DELEGATED OFFICER REPORT

WOKINGHAM
BOROUGH COUNCIL

Application Number:	241962
Site Address:	Hogwood Farm, Sheerlands Road, Arborfield, Wokingham, RG40 4QY
Expiry Date:	7 April 2025
Site Visit Date:	10 July 2024
Proposal: Application for approval of Reserved Matters pursuant to Outline Planning Consent O/2014/2179 (as varied by 181194, dated 14/11/2018). The Reserved Matters comprise details of 18 no. dwellings, commercial floorspace (Use Class E) and public open space within the Neighbourhood Centre parcel together with associated access, parking, drainage and play infrastructure. Details of access, appearance, landscaping, layout and scale to be considered.

Figure 1: Area available for the delivery of school

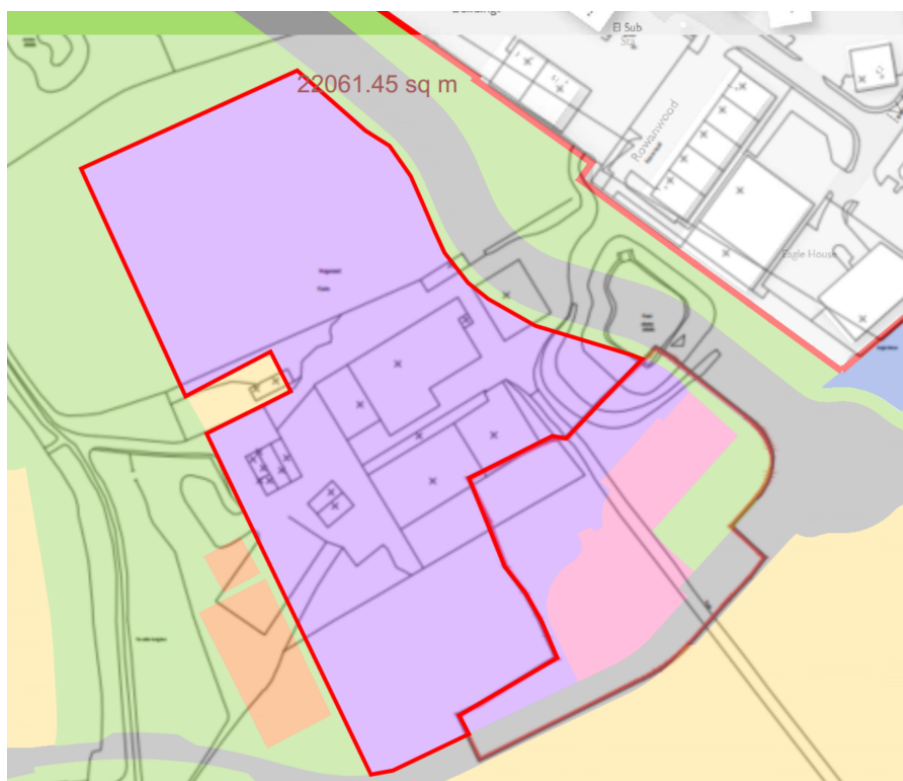
8. The Land Use Parameter Plan allocated 0.296 hectares for the Neighbourhood Centre, excluding 0.04 hectares of civic space secured under the s.106 Legal Agreement. The current application covers approximately 0.63 hectares, including 0.15 hectares of civic space comprised within the area of public open space, thereby exceeding the envisaged quantum for each land use in the Land Use Parameter Plan and S106 Agreement. To accommodate this expansion, the Neighbourhood Centre footprint has been extended into land originally designated for a primary school. The s.106 Agreement requires the applicant to transfer no less than 2.5 hectares to the Council for the school's delivery. Following this proposal, approximately 2.2 hectares remains available for the school site, as shown in Figure 1 below.

10. To ensure the proposal does not compromise the future delivery of a school for the Hogwood Farm (Finchwood Park) development, officers requested the submission of an indicative school layout. The submitted indicative school site layout demonstrates that sufficient space would be available for staff parking, the school building, and sports facilities. The WBC Property and Education teams have reviewed the proposal and confirmed that the remaining 2.2-hectare site exceeds the Department for Education's recommended minimum area for a school (as per BB103 standard). Given that the proposal secures an appropriate school pick-up/drop-off provision through shared parking facilities – to be delivered by the applicant as part of the Neighbourhood Centre proposals – it is considered that the development not only safeguards but also supports the delivery of the future school.
